APPLICATION NO.	FILING DATE	FIRST NAMED INVENTOR	ATTORNEY DOCKET NO.	CONFIRMATION NO.
10/729,410	12/04/2003	Michael Bret Hartmann	034043-002	9612

Office Action Summary

This is the first office action for application number 10/729,410, Illuminated Jack Stand, filed on December 4, 2003.

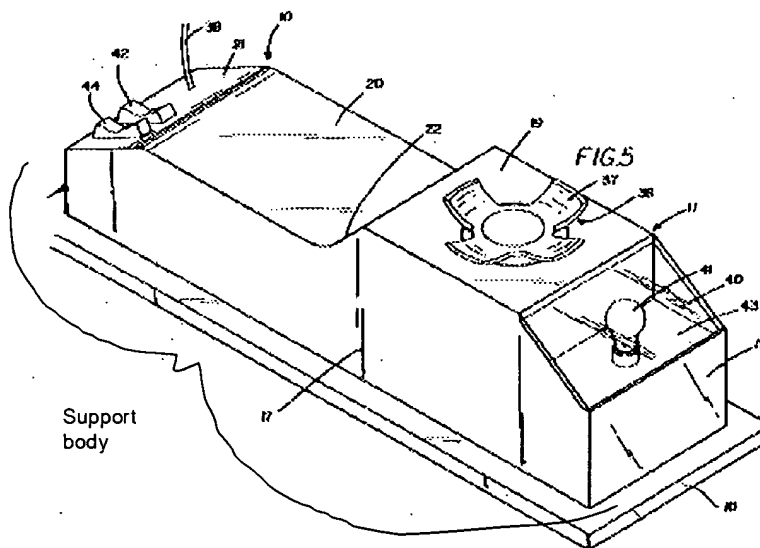
Claims 1-4 and 14 are rejected under 35 U.S.C. 102(b) as being anticipated by U.S. Patent number 5,992,826 to Simmonds.

Simmonds '826 discloses a jack stand (figure 5) comprising a support body (above), a vertically movable post (28,37) received within the support body, and a light source (41) mounted in the support body, wherein the light source is mounted in the body to illuminate at an upward angle from about 20-70 degrees

from the horizontal, and from about 40-60 degrees from the horizontal (with reference to figure 5, the light source clearly illuminates from approximately -45 degrees to the horizontal through about 180 degrees, so the above mentioned ranges are clearly satisfied), wherein the stand includes a mechanism (23, 27, 35, etc.) for controlling the vertical height of the vertically movable post with respect to the support body.

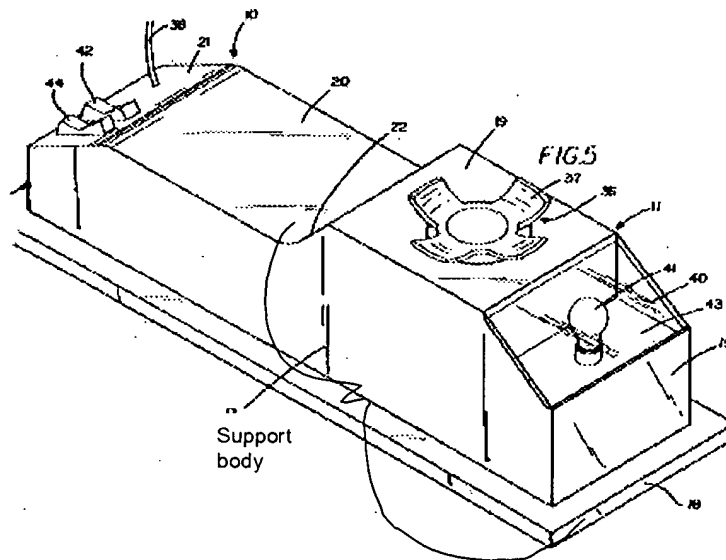
Regarding claims 7 and 8, Simmonds '826 teaches the previous invention wherein the light source is adjusted via a switch (42) mounted in the support

body, but fails to specifically divulge the switch to be an adjustable dimmer switch.

However, Camarota et al. '704 teaches the use of dimmer switch (page 2, paragraph 23) to dim a light source. It would have been obvious to one of ordinary skill in the art at the time the invention was made to have replaced the switch of Simmonds '826 with a dimmer switch as in Camarota et al. '704 since it is well known in the art that doing so can reduce electricity consumption in addition to allowing an operator to select a desired amount of illumination.
